IAI WESTWIND

SERVICE BULLETIN

INDEX

**DOUBLER INSTALLATION FRAME 194.00
FIGURE 3**

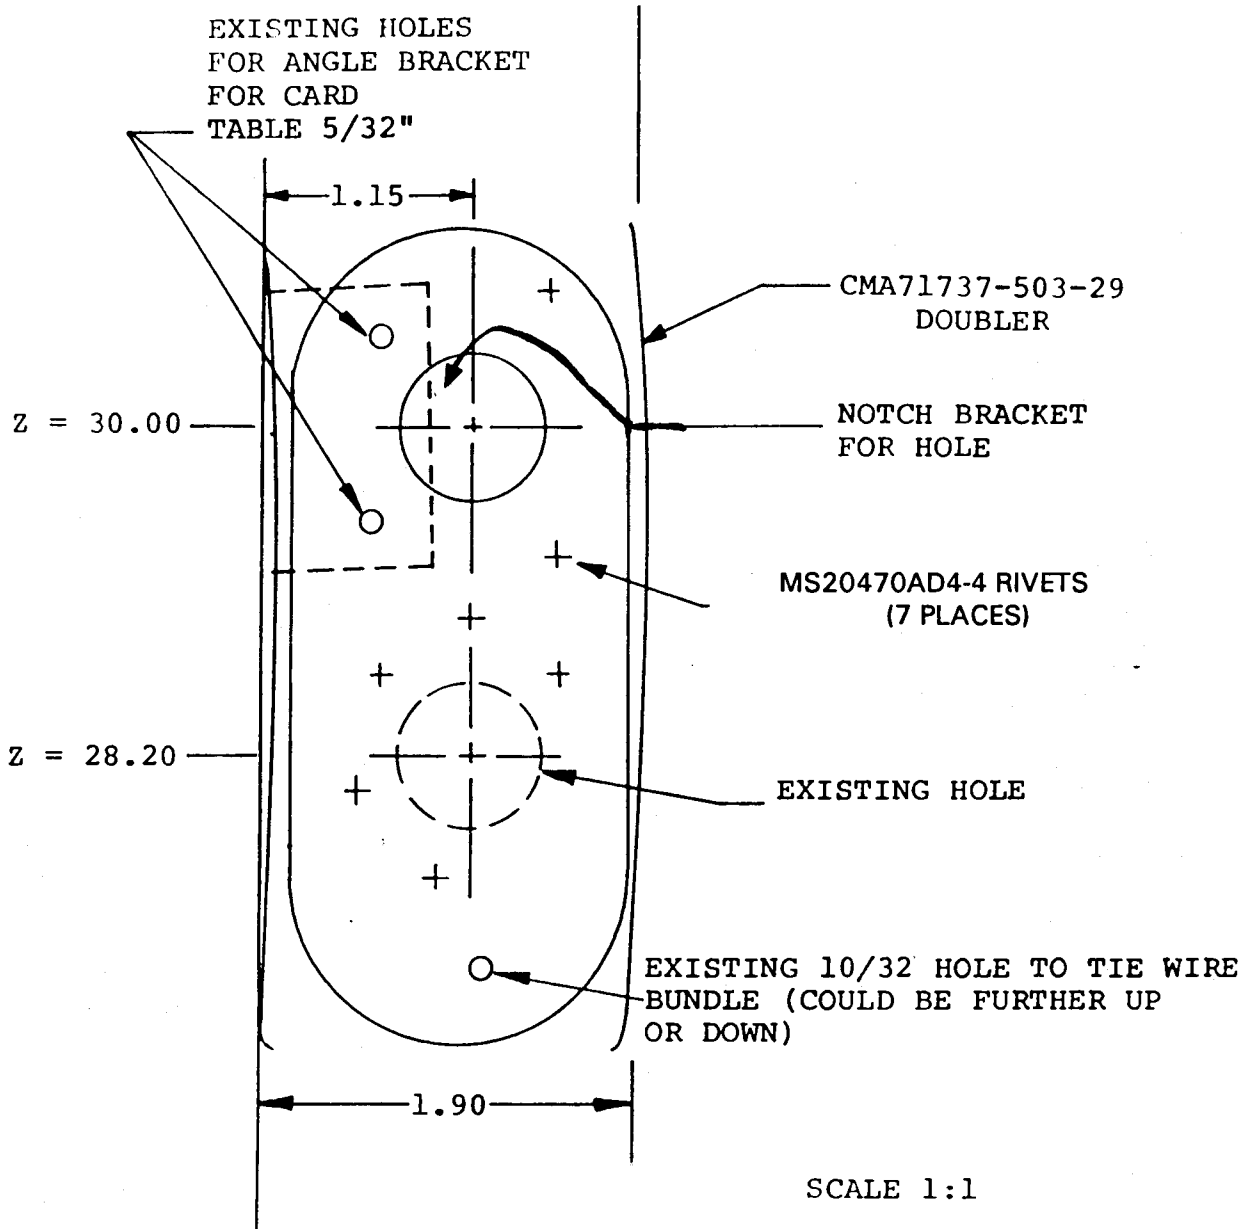
- (b) Doubler for frame at Sta. 194 must be of sufficient length to cover the existing hole at Z station 28.20. Refer to Figure 3.
 - (c) Install NAS1033-A3 nutplate on aft side of frames at Sta. 210.00 and 201.75 for Adel clamp to support tube.

FIGURE 1

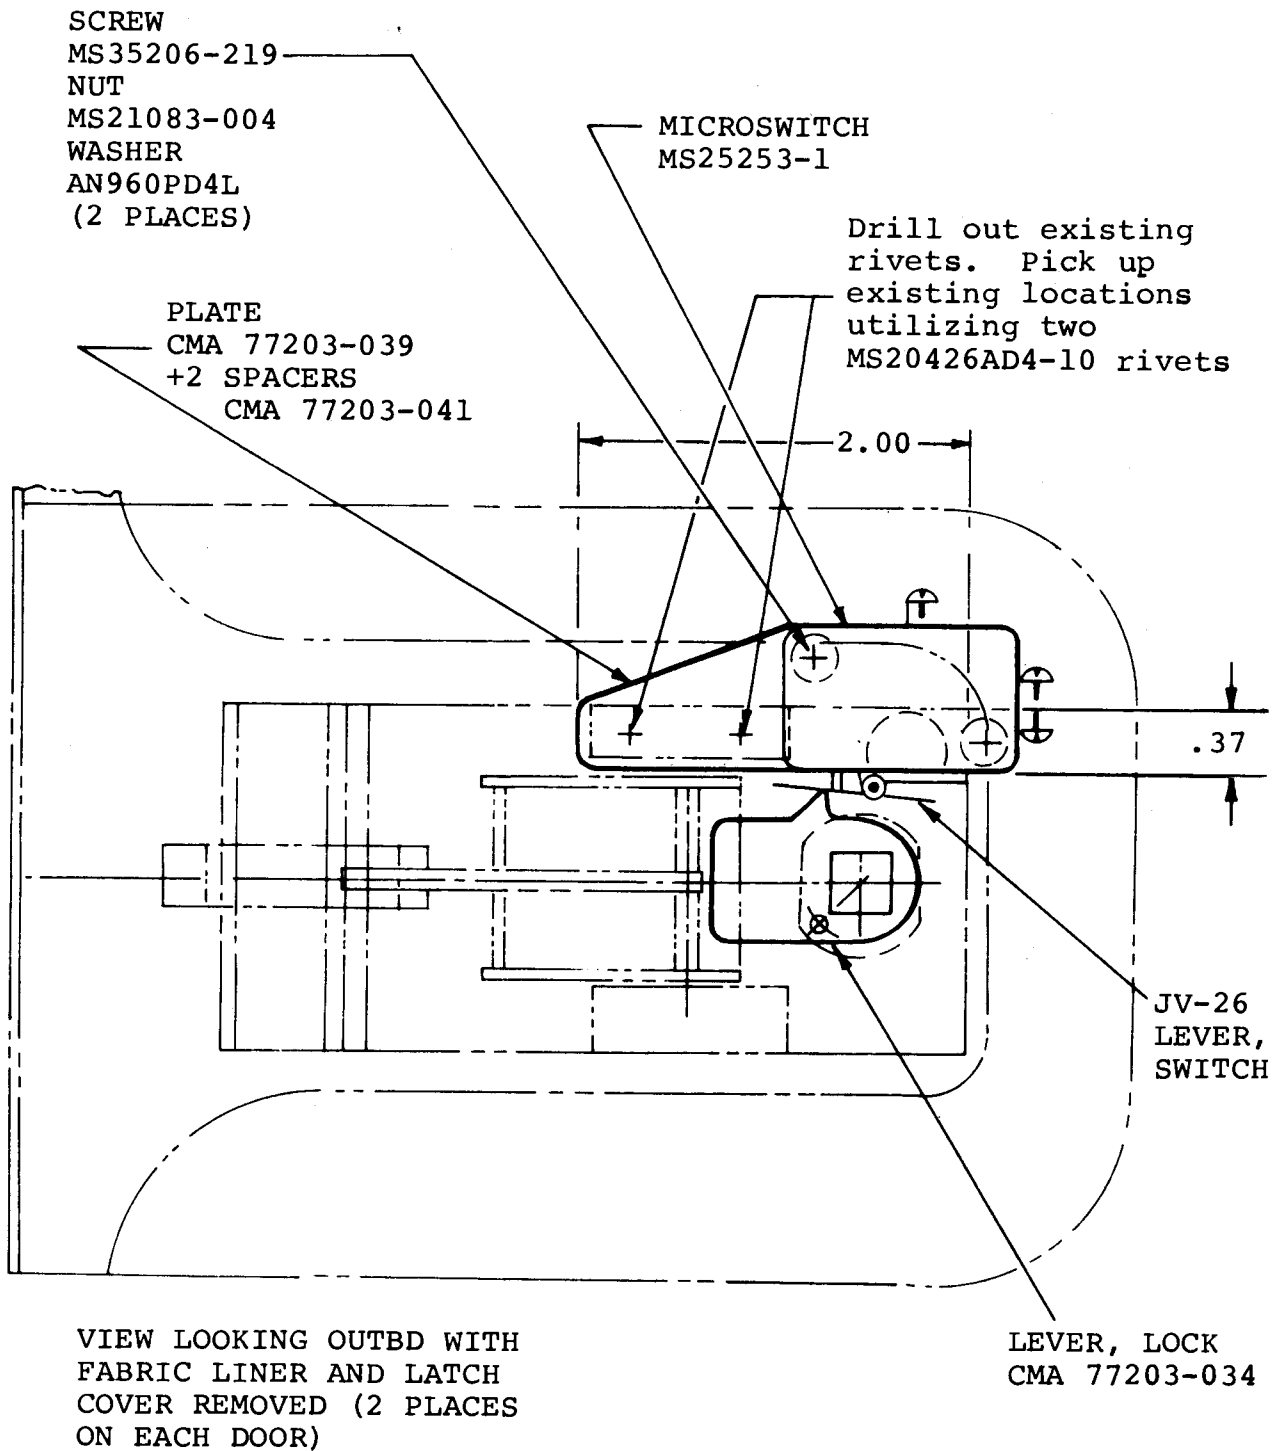
- F. Locate and drill two holes in the new CMA 77203-039 mounting plate as shown in Figure 1.
- G. Before installing the two new mounting plates, insert a CMA 77203-041 spacer in each of the existing counterbored holes in the upper hinge blocks. Install the new CMA 77203-039 mounting plates on the two upper hinge blocks (using existing rivet holes) and rivet in place utilizing MS2042AD4-10 rivets. (See Figure 2).

FIGURE 1 DOOR-STAY EYE-BOLT RELOCATION

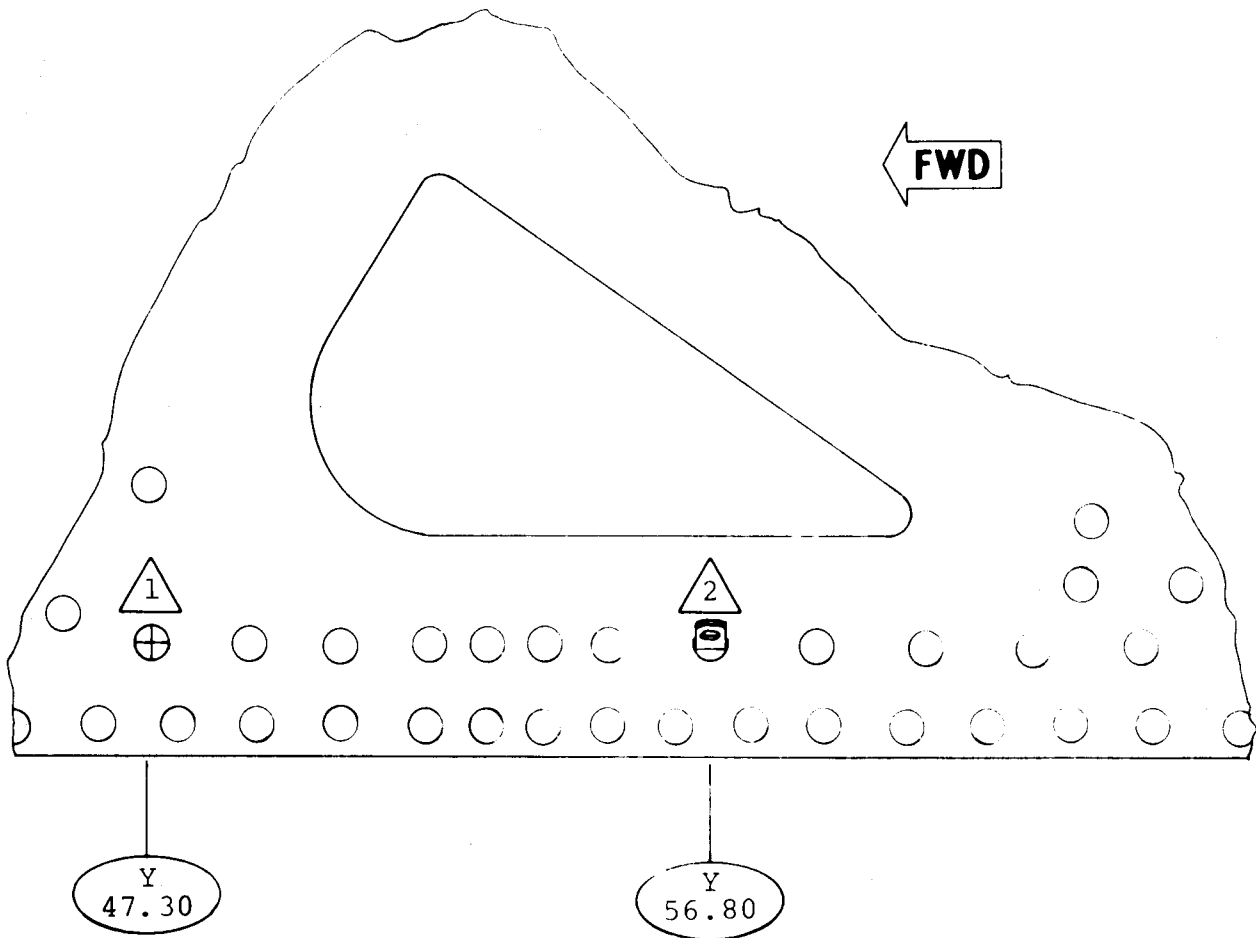
C. Move eye-bolt P/N 5123617-15 from its existing location to position shown in Figure 1. Plug old hole with screw removed to install eye-bolt in new location.

1. REMOVE EYE BOLT P/N5123617-15 AND RELOCATE BETWEEN STATION Y-53.00 & Y-56.80 ACCORDING TO MAXIMUM OPEN POSITION. USE ONE OF EXISTING SCREWS LOCATED BETWEEN THESE STATIONS.

2. REMOVE SCREW AND RELOCATE TO STATION Y-47.30 WHERE EYE-BOLT WAS REMOVED

FIGURE 2 DOUBLER AND DOOR-STAY INSTALLATION

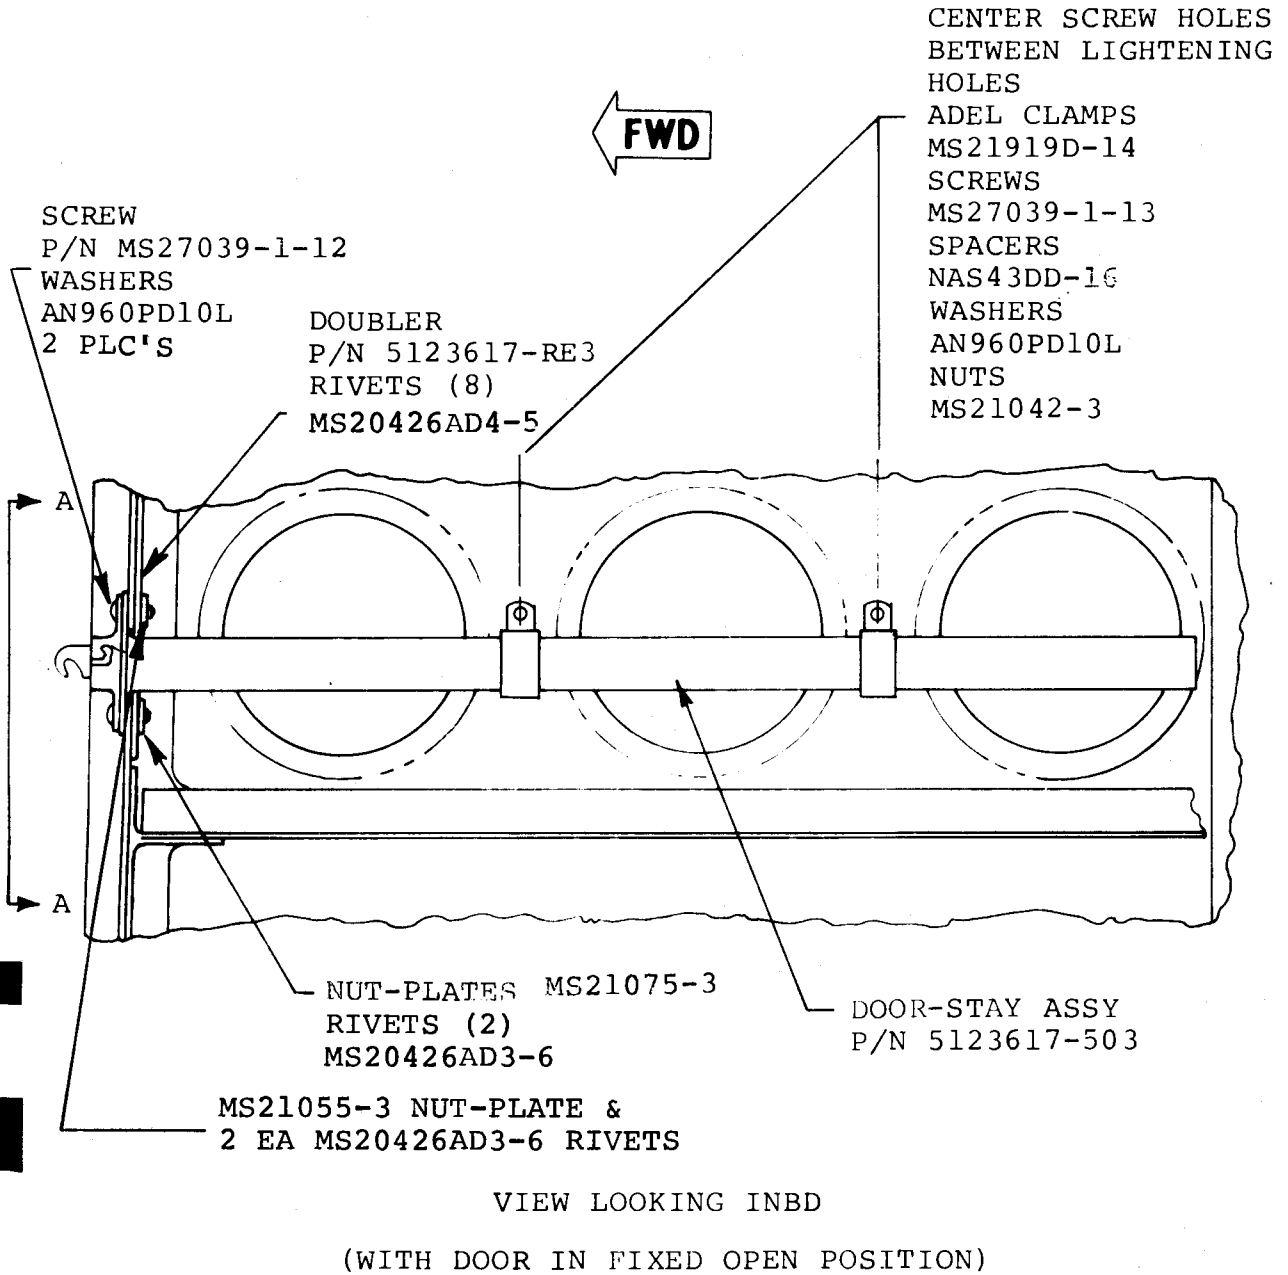
- M. Drill two #10 (.193 inch dia.) holes midway between lightening holes to secure Adel clamps. Ref. Figure 2.
- N. Install two MS21919DG-14 Adel clamps with MS27039-1-13 screws, NAS43DD-20 spacers, two AN960PD10L washers and MS21042-3 nuts, (supplied with door-stay Ass'y).

FIGURE 3 DOUBLE AND DOOR-STAY INSTALLATION

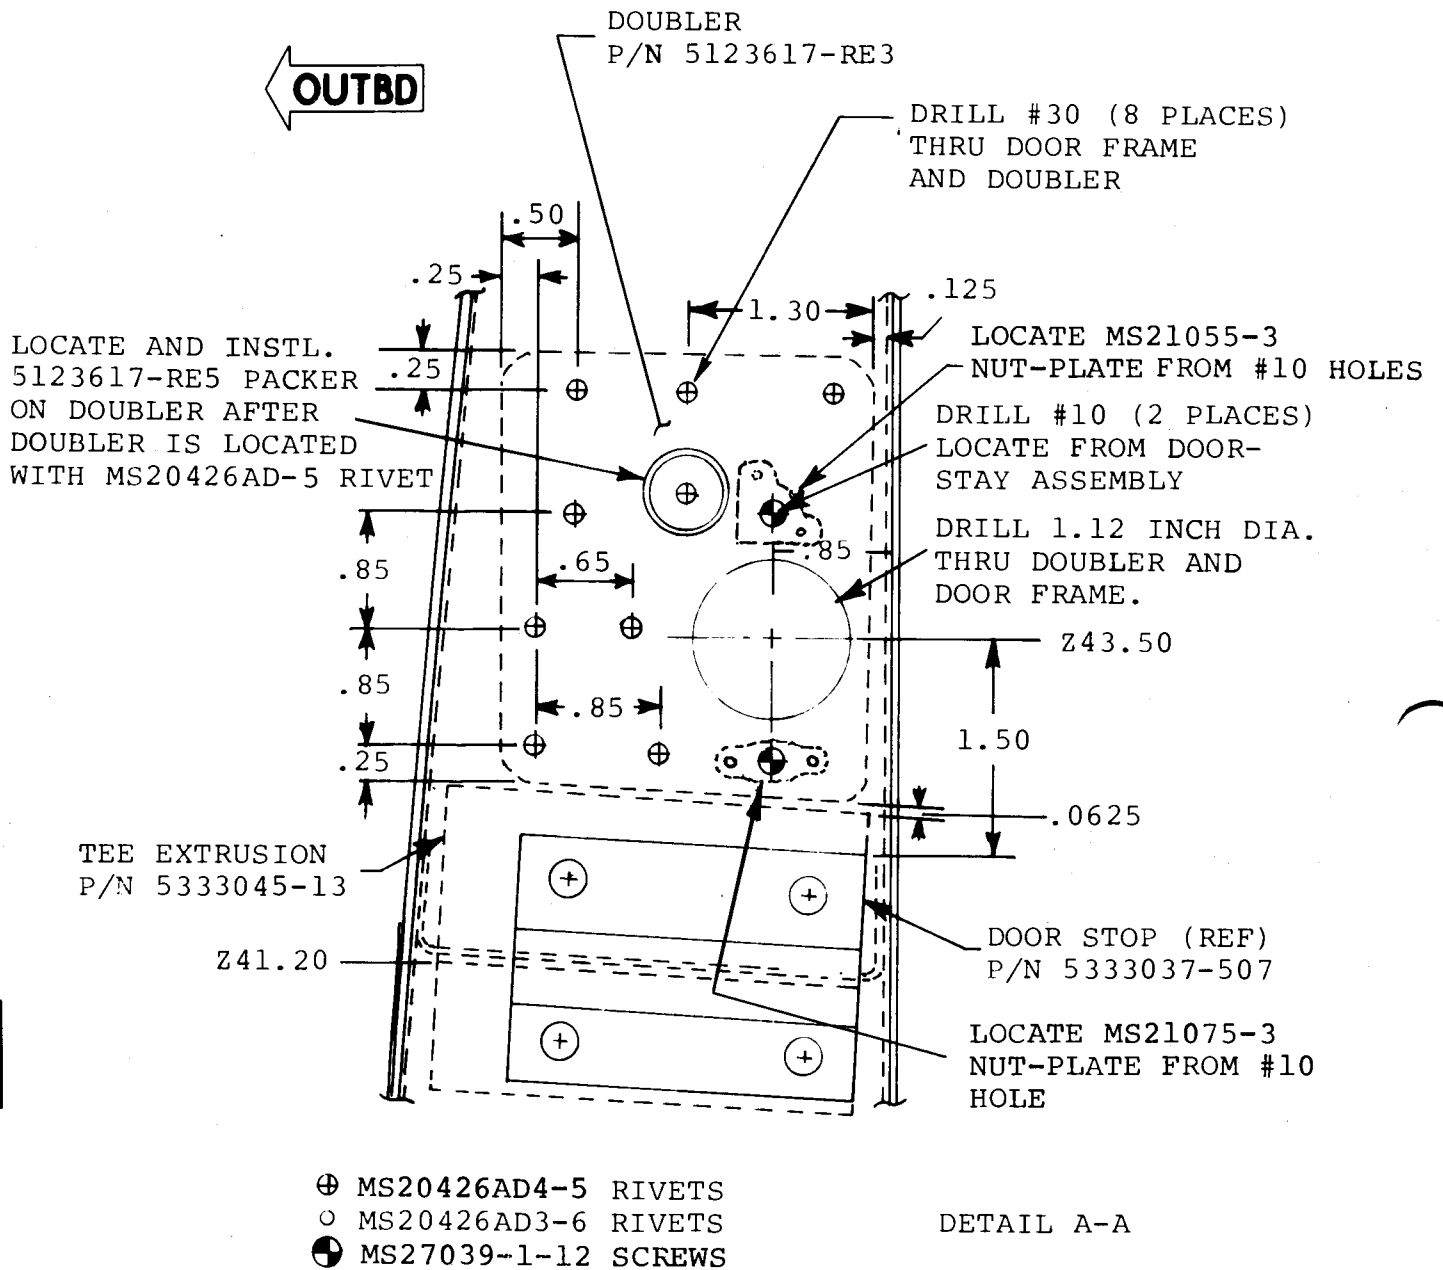
E. Locate doubler P/N 5123617-RE3 per Figure 3 and drill eight #30 (.128 inch dia.) holes.

F. With doubler secured in place, temporarily locate and drill 1.12 inch dia. hole through door and doubler. Ref. Figure 3.

- H. Remove stay assembly, locate nut-plates and drill #40 (.098 inch dia.) holes for mounting nut-plates with four (4) MS20426AD3-6 rivets. Ref. figure 3.

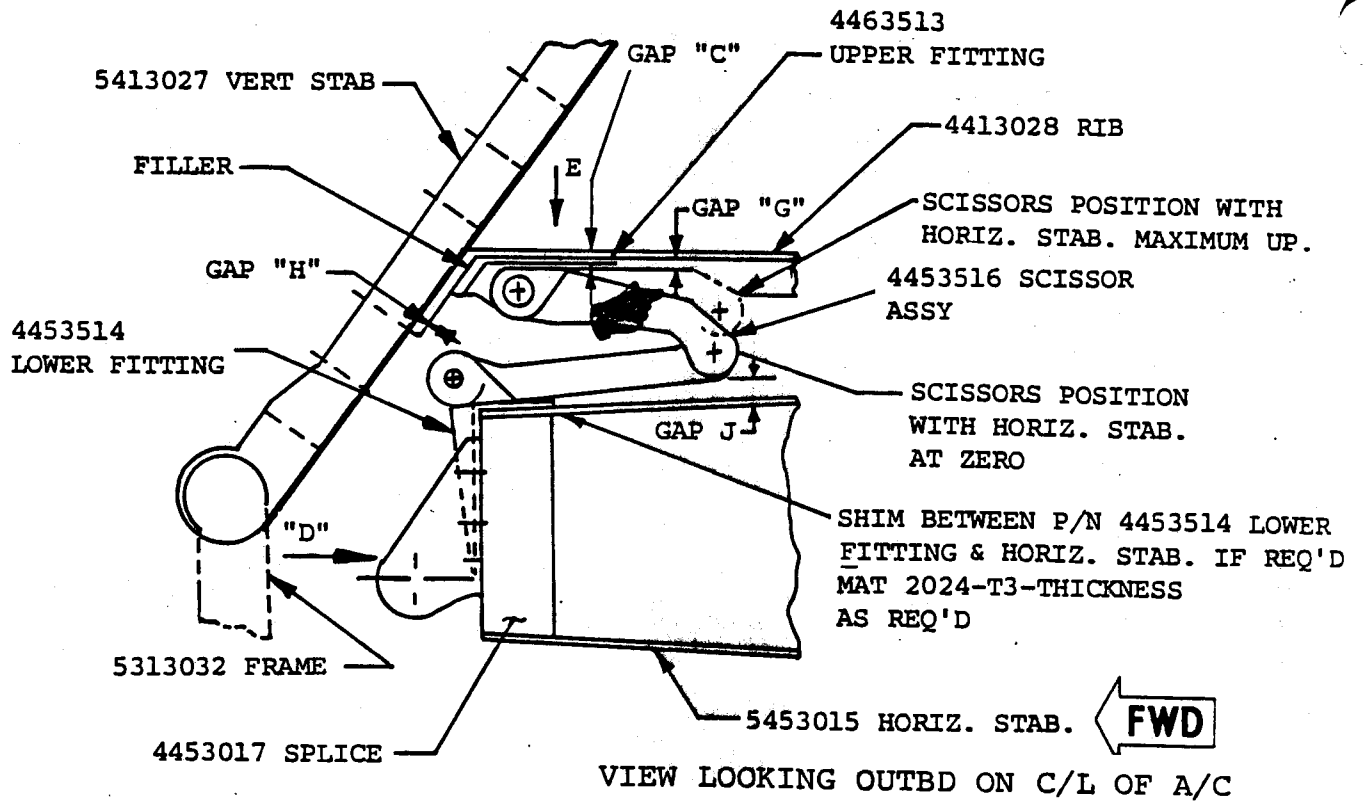
2.G.(1.7) Revised text in following paragraph to read as follows:

(page 19) If the reading of the dial indicator exceeds 0.010" on either lug, it is recommended to perform the improved installation as per Para. D.
